EB-2009-0425 – Hydro One Networks' Section 92 – Toronto Midtown Transmission Reinforcement Project – Responses to Interrogatory Questions

Ontario Energy Board (Board Staff) INTERROGATORY #1 List 1

Ref: Exhibit B, Tab 1, Schedule 2

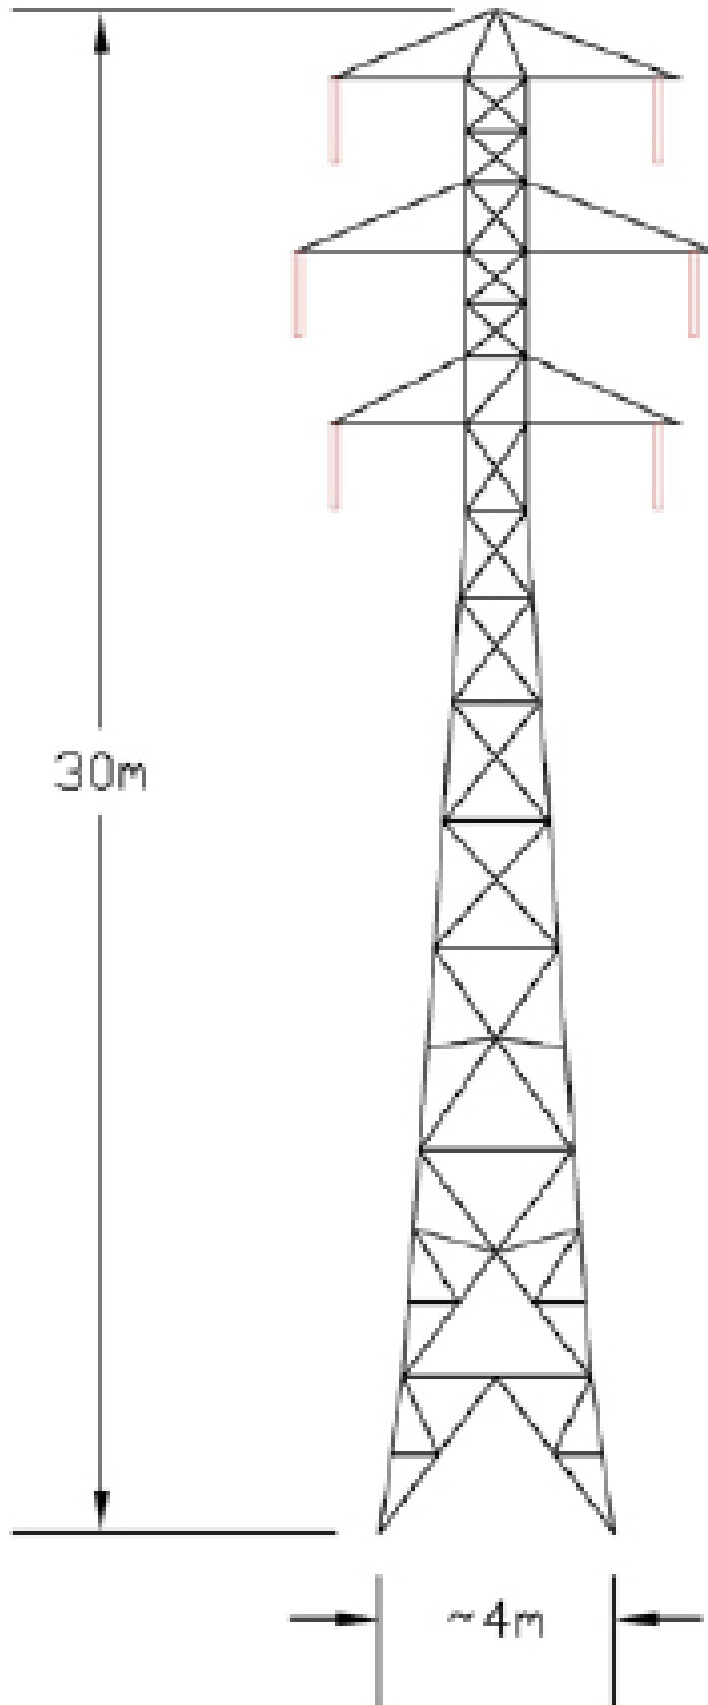
The map of existing facilities shows the three circuits L13W, L14W and L15W. Please provide diagrams showing the tower type and conductor arrangement for each of the tower lines.
